**SUPPORTING AND ADDITIONAL MATERIAL FOR PROPERTY: 6541 ORIOLE Dr. Dallas, TX 75209**

## STRUCTURAL INVESTIGATION & REPAIRS PHASE 1

# The Cockrum Residence

## Structural Review of Construction

**Detail 7**

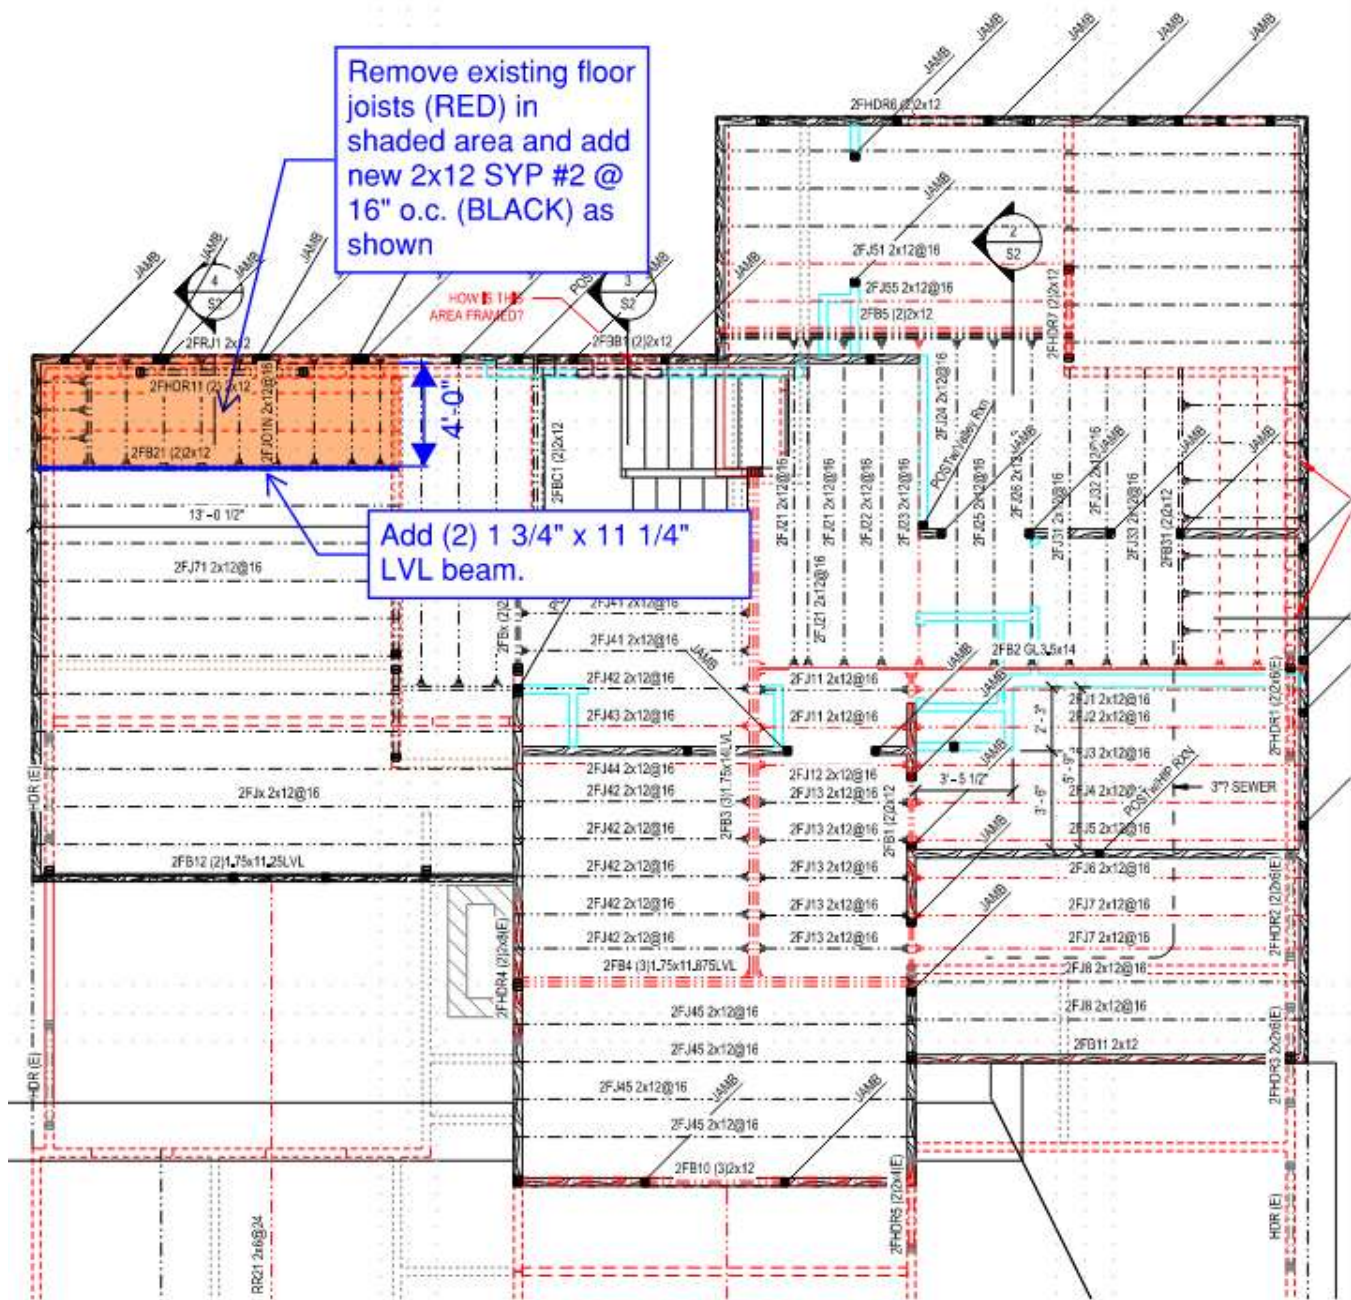
There are some floor joists that cantilever over the first-floor wall to provide a flush and smooth transition between the second-floor siding and first floor brick façade. To achieve this properly, framing must be turned perpendicular to one another, like the ceiling joist framing when the exterior wall turns ninety degrees. The location of this framing and their remedies can be found in the attached [Detail 7](#) and [Detail 8](#).

**Detail 9**

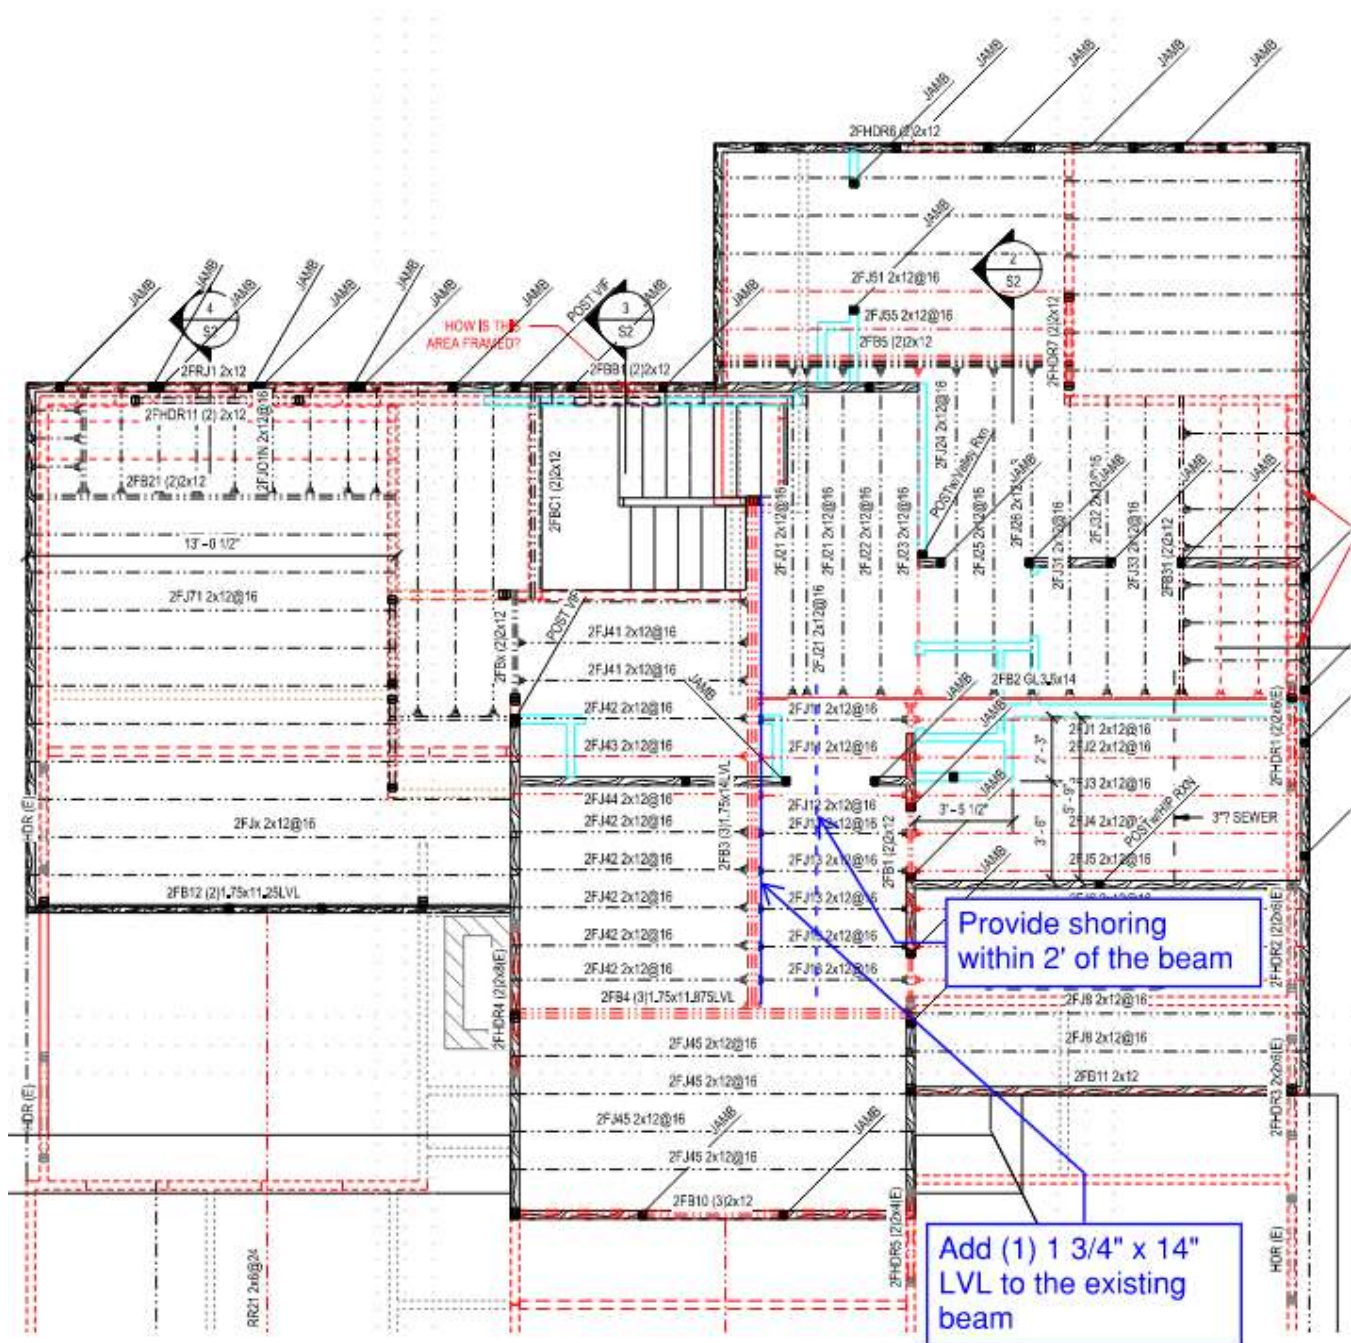
The large open area above the kitchen and living room could not be achieved without the use of large beams supporting the floor joists. I have reviewed the engineering for each of these beams and have found most of them to be insufficient. There are repairs that can be made to each of these beams to provide the adequate framing necessary to support the second floor. The locations and repairs needed can be foundation in [Details 9 through 14](#).

**Detail 16**

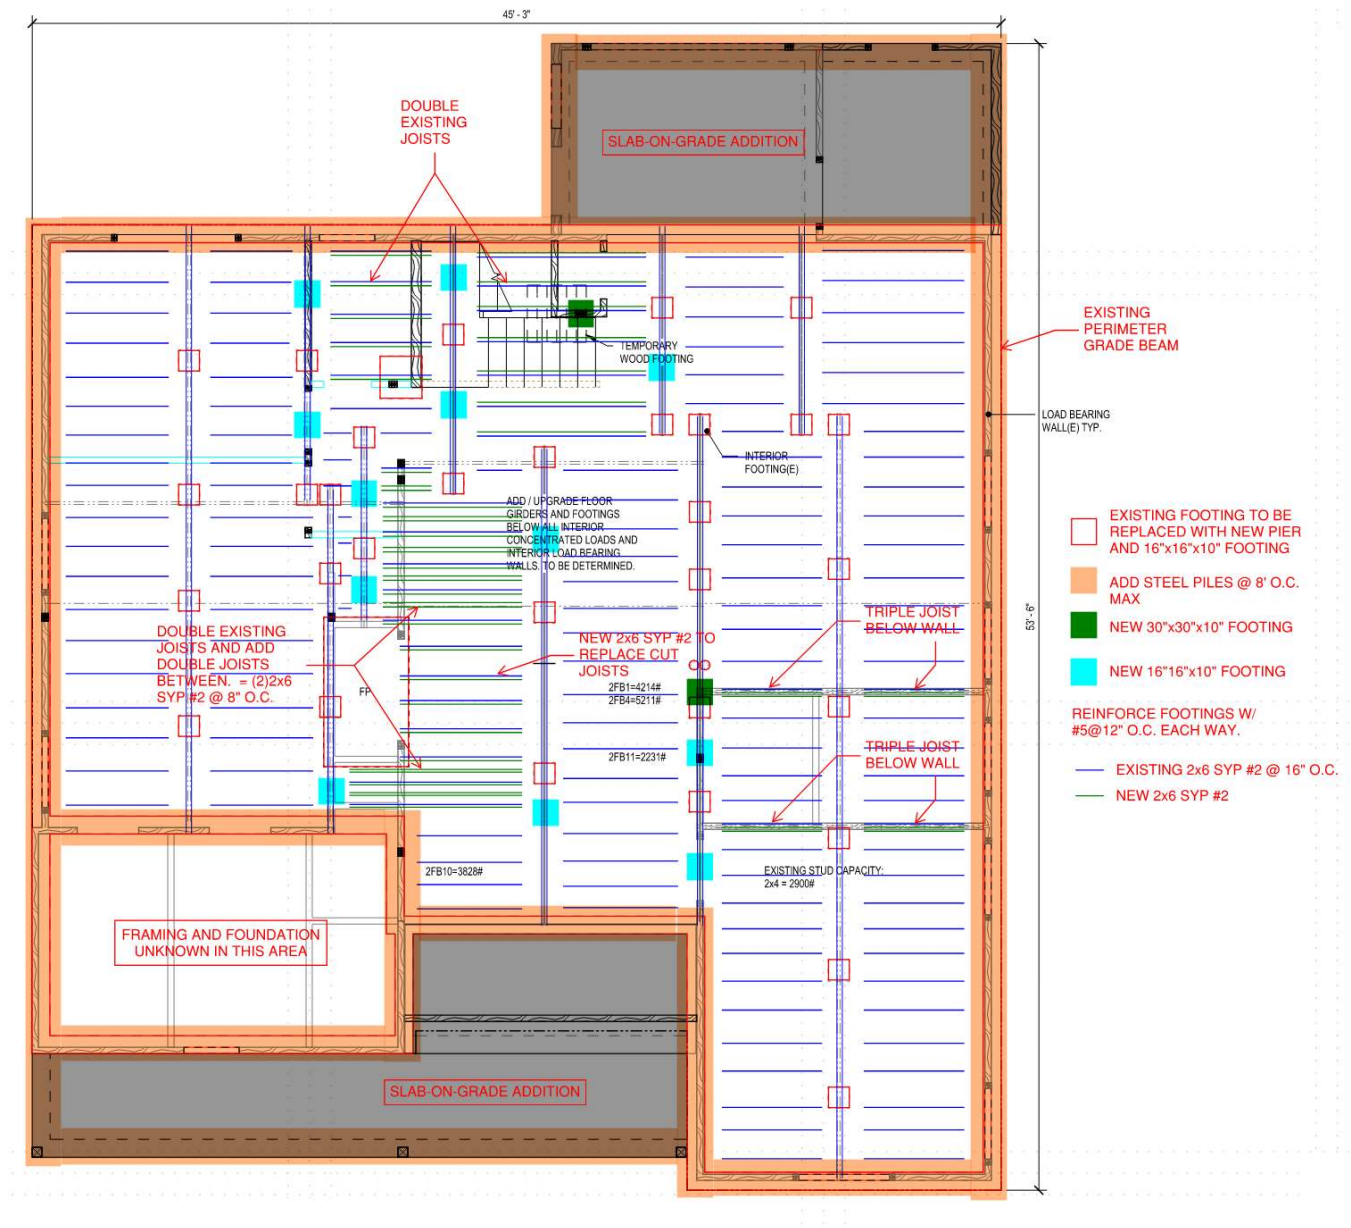
I have followed the load path of the new framing down through the foundation and have developed a potential plan for supporting the new load. The attached [Detail 16](#) shows existing pier locations provided by the homeowner based on a survey personally done by the homeowner. I have also shown where new piers need to be constructed to support the new framing conditions as well as where existing joist framing needs reinforced to also support new bearing walls and loading conditions. The foundation system currently has three foundation types, thus providing differential movements between the different types of foundation. In an effort to reduce the foundation types and get the foundation to act more uniformly, I recommend adding piers around the perimeter of the original foundation as well as around the perimeters of the new slab-on-grade foundations. I also recommend that the existing interior piers be replaced to match the interior piers required for the new loads from the second floor. This will ensure a more uniform foundation without the differential movements, which is how the foundation performed for the homeowner prior to the addition of the second floor. [Detail 17](#) shows the new pier and footing construction to be used. This pier detail is based on the allowable bearing load of 1,500 psf per 2015 IRC Table R401.4.1 for CL, ML, MH and CH soils, which are abundant in the Dallas area. The new piers around the old and new foundation perimeters should be steel piles down to refusal.

Detail 19

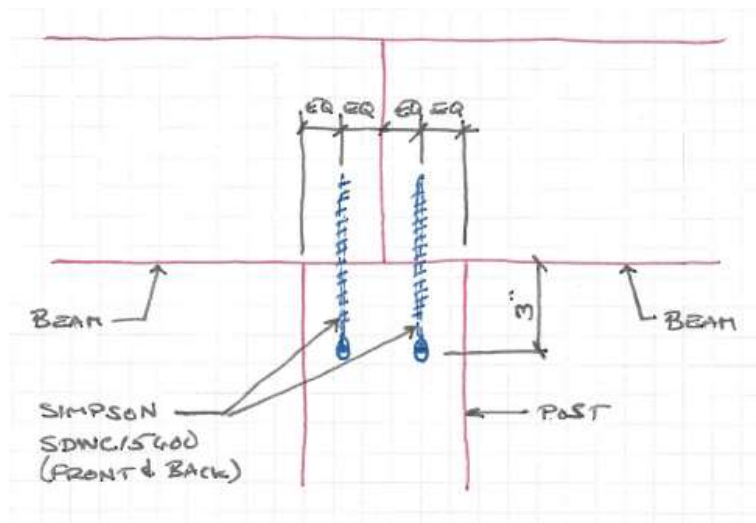
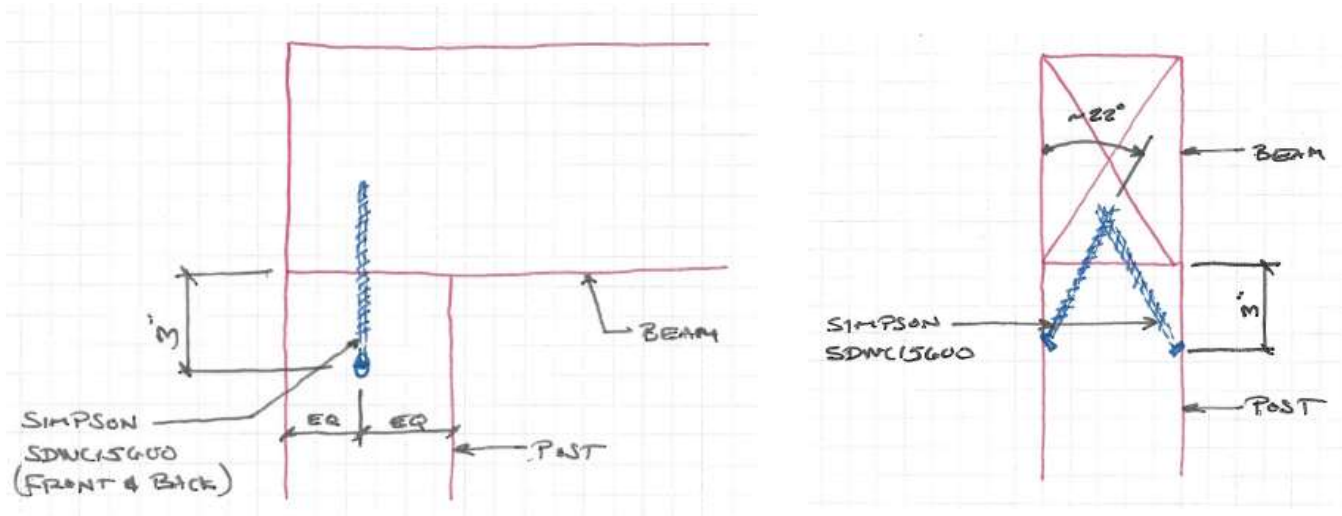
The new front patio framing also has a couple of issues. One, the posts do not have any anchorage to the foundation. I would recommend using the Simpson retrofit post base, RPBZ, to provide the appropriate anchorage at each of the posts. The corner posts will require only one (1) RPBZ and the interior posts will require two (2) RPBZ. The second issue is the roof over the patio visually appears to be sloping downward from right to left. This slope was not present when I visited the residence in June last year and has been slowly increasing since then. This potentially points to an issue with the foundation, which will be discussed later in this report. A third patio framing issue concerns a lack of any connection between the front patio beams and the posts. Should the beams be lifted to level, a Simpson post cap, PCZ, can be installed between the top of the post and the bottom of the beam at that time. Use an EPCZ for the end posts and a PCZ for the interior posts. If the beams are not lifted, then Simpson SDWC15600 screws can be used to anchor the beams to the post per [Detail 19](#).
